ADDENDUM NO. 1 TO PROJECT NO. 45444

**CONSTRUCTION WORK, HVAC WORK, PLUMBING WORK AND ELECTRICAL WORK
PROVIDE ENCLOSED FIRING RANGE
AUBURN CORRECTIONAL FACILITY, QWL SITE
3579 FRANKLIN STREET ROAD
SENNETT, NY**

February 13, 2019

6
S502
TYPICAL HIGH/LOW ROOF INTERFACE TEE/PC COLLECTOR BEAM SECTION - NTS

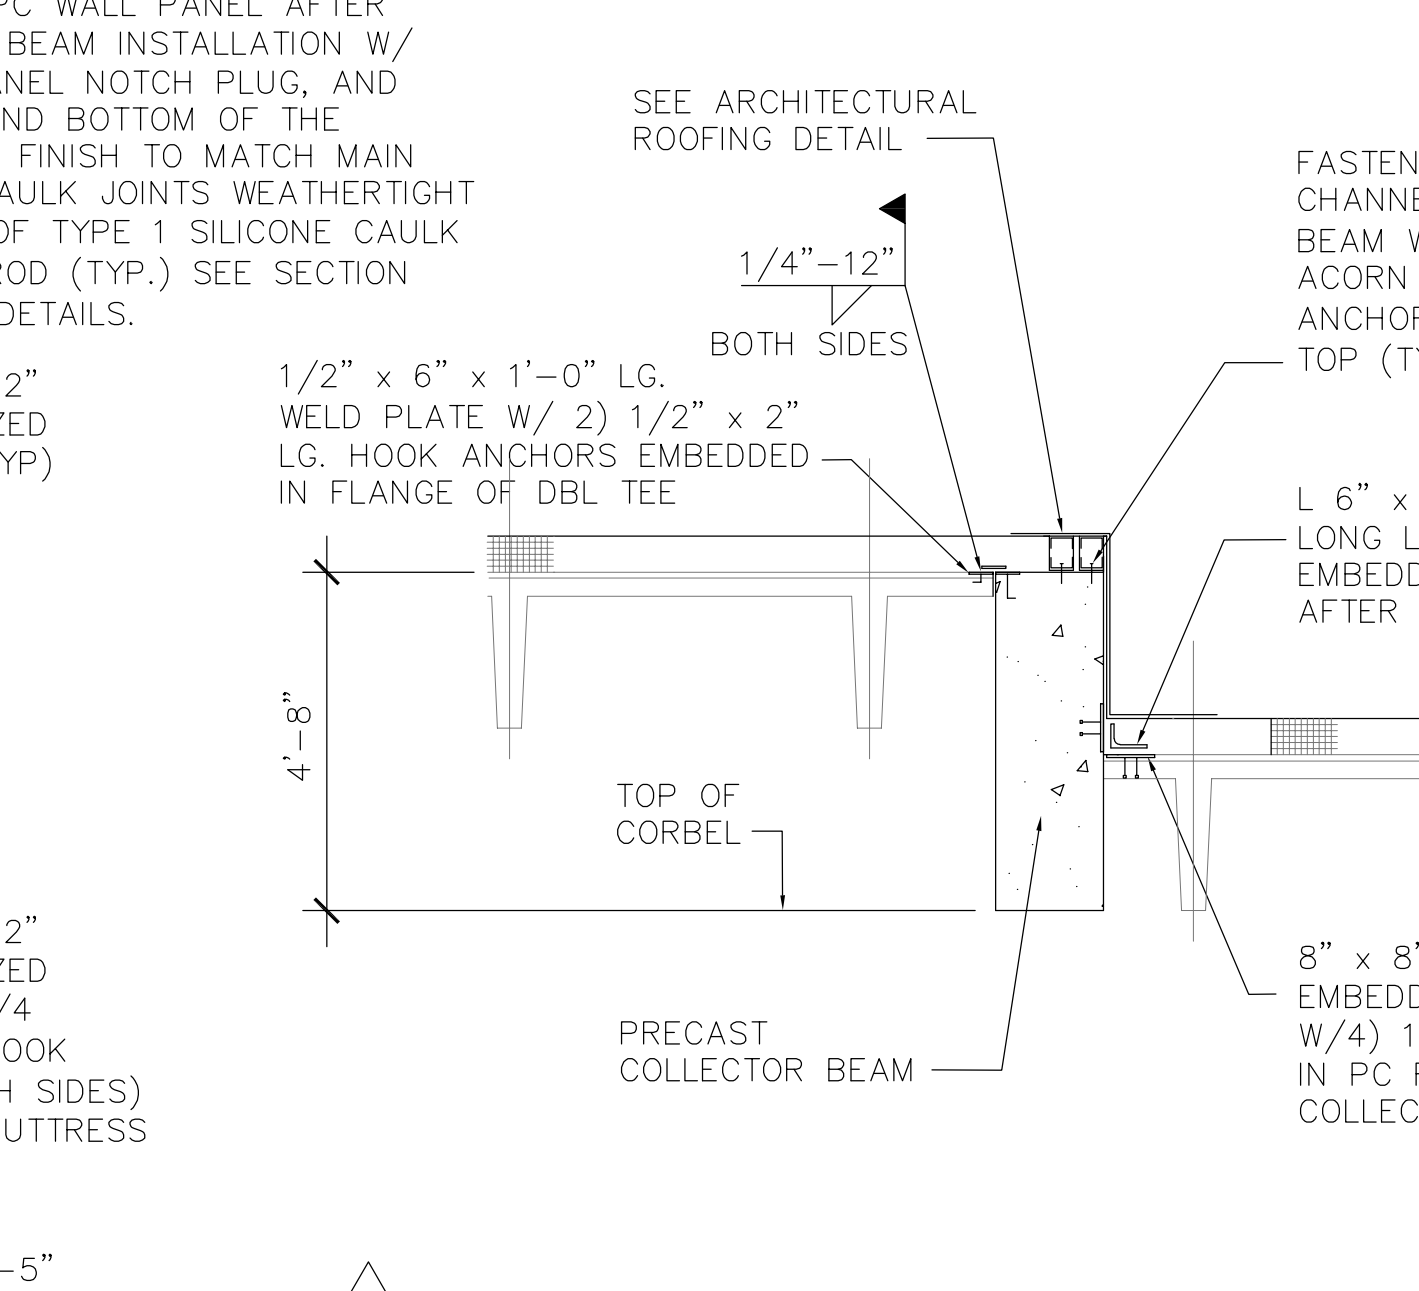
NOTE:
1. SPACE WELD PLATES IN DOUBLE TEES AND COLLECTOR BEAMS @ 5'-0" O.C. PER TEE MANUFACTURER.
2. THE EXISTING SECTION ON S-502 IS DELETED AND REPLACED WITH THIS SECTION.
